Product Change Notice (PCN)

PCN Number: **PCN-0451143R-01**

Product(s) Affected: PJ-035DH

PREVIOUS CUI DEVICES DETAIL / IMAGE

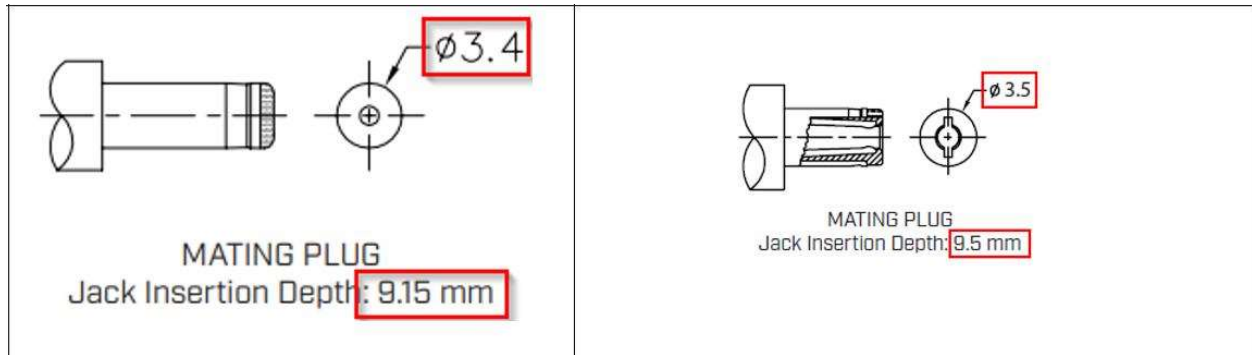
Description of Change: mechanical, and material differences as shown below:

Technical drawing of the previous CUI device showing dimensions and part numbers. Key dimensions include: 9.0 [0.354], 11.0 [0.433], 6.50 [0.256], 3.00 [0.118], 4.7 [0.185], 3.5 [0.138] (2 PLCS), 14.5 [0.571], 3.50 [0.138], 2.50 [0.098] (2 PLCS), 3.0 [0.118], 10.7 [0.421], 3.0 [0.118], and 10.7 [0.421].

Technical drawing of the new CUI device showing dimensions and part numbers. Key dimensions include: 9.0, 11.0, 6.5, 4.0 [0.3], 2.5, 4.0 [0.3], 14.0 [0.3], 3.0, 17.0 [0.3], 10.7 [0.3], 13.7 [0.3], 2.5, 4.0 [0.3], and 2.5.

PCB LAYOUT TOP VIEW. Key dimensions and part numbers include: 7.7 [0.303], 1.00X3.00 (2 PLCS), 1.00X3.50, 4.7 [0.185], 3.0 [0.118], and 3.0 [0.118].

Recommended PCB Layout Top View. Key dimensions and part numbers include: 13.7, 7.5, 1.00X3.00 (2 PLCS), 1.00X3.50, 4.7 [0.185], 3.0 [0.118], and 3.0 [0.118].

MATERIAL	PLATING
center pin	copper	nickel
terminal 1	brass	silver
terminal 2	copper alloy	silver
terminal 3	brass	silver
plastic	PBT

DESCRIPTION	MATERIAL	PLATING/COLOR
center pin	brass	nickel
terminal 1	brass	silver
terminal 2	bronze	silver
terminal 3	brass	silver
cover	PBT (UL94V-0)	black
housing	PBT (UL94V-0)	black
